UNITED STATES ' NUCLEAR REGULATORY COMMISSION WASHINGTON, D. C. 20555

WPPSS NUCLEAR PROJECT NO. 2

AMENDMENT TO FACILITY OPERATING LICENSE

Amendment No. 59 License No. NPF-21

Table 3.2.3-1

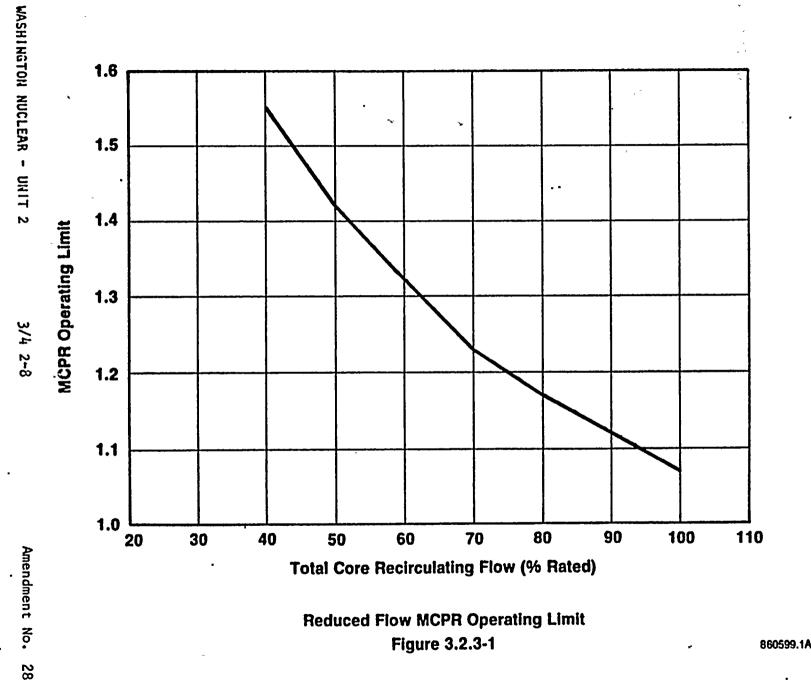
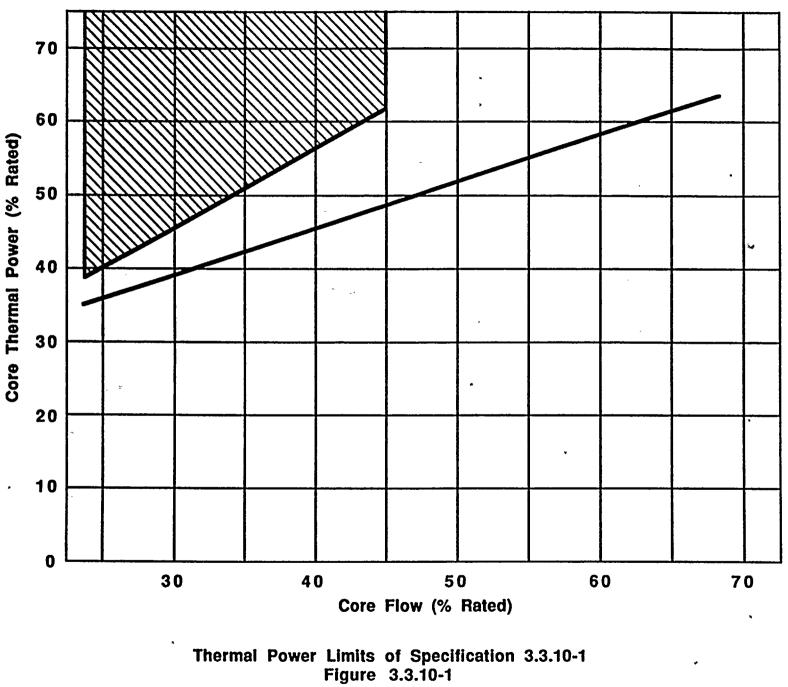
MCPR Opera <u>Up to 106%</u>	ting Limit Core Flow
1	Cycle Exposure	Equipment Status	<u>GE Fuel</u>	ANF Fuel
1.	0 <u>MWD</u> - 3750 <u>MWD</u> MTU MTU	*	1.40	1.28
2.	3750 <u>MWD</u> - EOC <u>MWD</u> MTU MTU	Normal scram times**	1.40	1.31
3.	3750 <u>MWD</u> - EOC <u>MWD</u> MTU MTU	Control rod insertion bounded by Tech. Spec. limits (3.1.3.4 - p 3/4 1-8)	1.50	1.38
4.	3750 MWD - EOC MWD MTU MTU	RPT inoperable Normal scram times	1.50	1.37
5.	3750 MWD - EOC MWD MTU MTU	RPT inoperable Control rod insertion bounded by Tech. Spec. limits (3.1.3.4 - p 3/4 1-8)	1.55	1.43

**These MCPR values are based on the ANF Reload Safety Analysis performed using the control rod insertion times shown below (defined as normal scram). In the event that surveillance 4.1.3.2 shows these scram insertion times have been exceeded, the plant thermal limits associated with normal scram times default to the values associated with Tech. Spec. scram times (3.1.3.4-p 3/4 1-8), and the scram insertion times must meet the requirements of Tech. Spec. 3.1.3.4.

Position Inserted From Fully Withdrawn	Slowest measured average control rod insertion times to specified notches for all operable control rods for each group of 4 control rods arranged in a <u>a two-by-two array (seconds)</u>	
Notch 45	.404	
Notch 39	.660	
Notch 25	1.504	
Notch 5	2.624
